Subject: Byron Generating Station Units 1 and 2
Braidwood Generating Station Units 1 and 2
Steam Generator Tube Vibration
NRC Docket Nos. 50-454, 50-455, 50-456,
and 50-457

ATTACHMENT A

FSAR Revisions to Implement 90/10

Feedwater Flow Split

Figure 4.4-3.
Reactor Coolant System Temperature
Percent Power Map

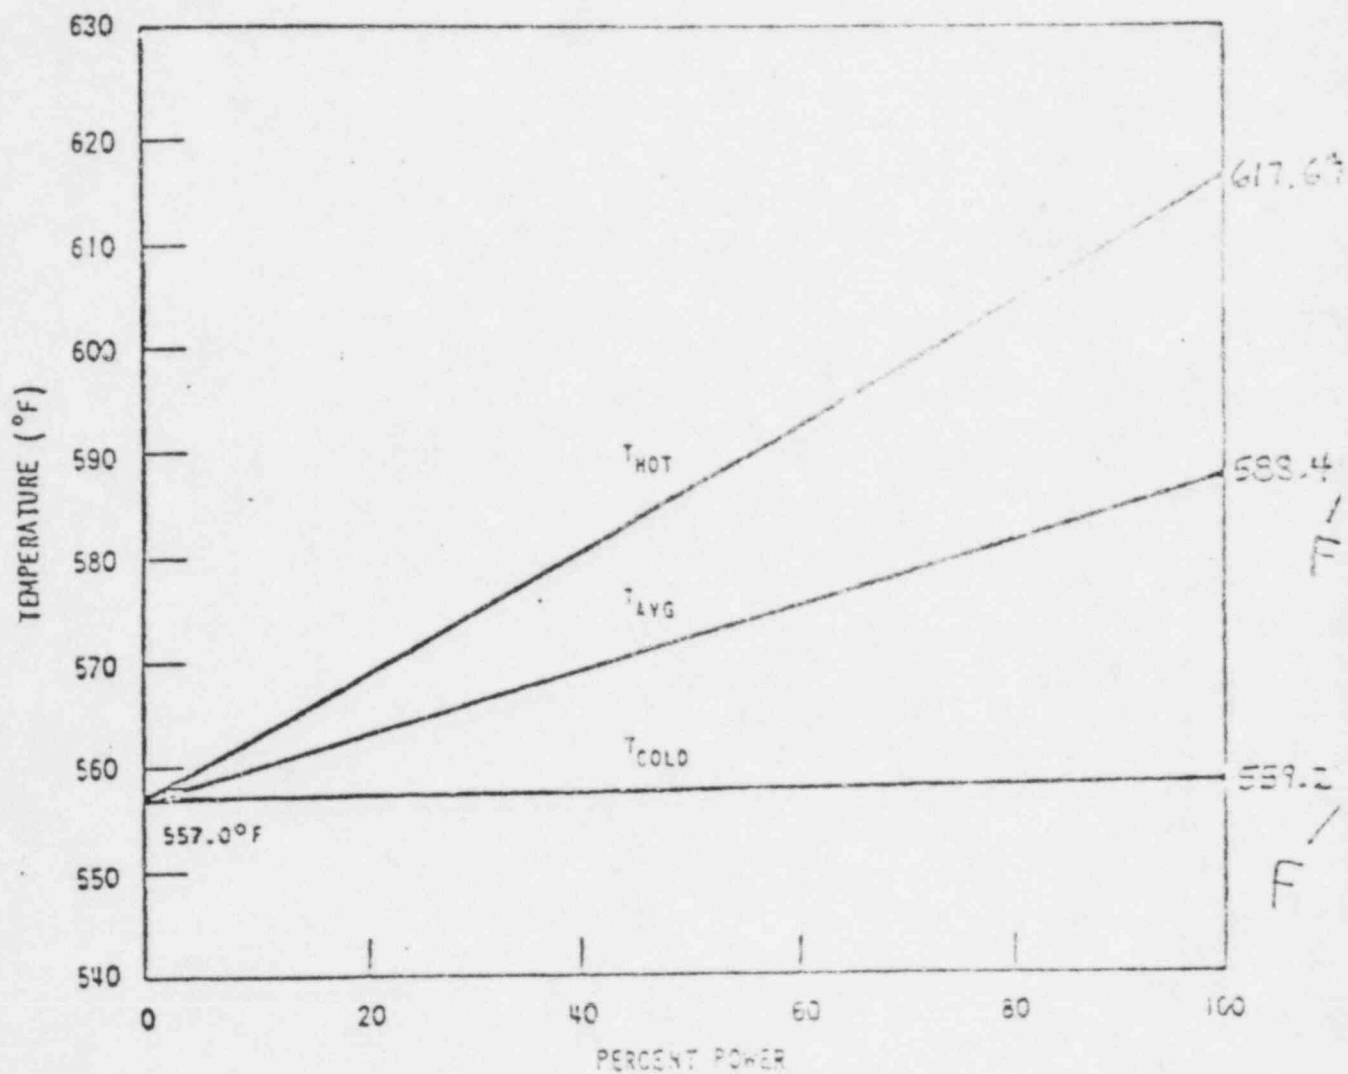
1. Table 3.6-12	Corrections
2. Table 3.9-16	Revisions
3. Table 4.1-1	Revisions and Corrections
4. Table 4.4-1	Revisions and Corrections
5. Figure 4.4-9	Revisions
6. Page 5.1-4	Revisions
7. Table 5.1-1	Revisions
8. Figure 5.1-2	Revisions
9. Section 5.4.2.5.3	Replacement Section
10. Section 5.4.2.5.4	New Section
11. Table 6.2-58	Revisions
12. Section 10.4.7.3	Replacement Section
13. Section 15.0.3.2	Revisions
14. Figure 3.6-2	Revisions
15. Figure 10.4-1	Revisions
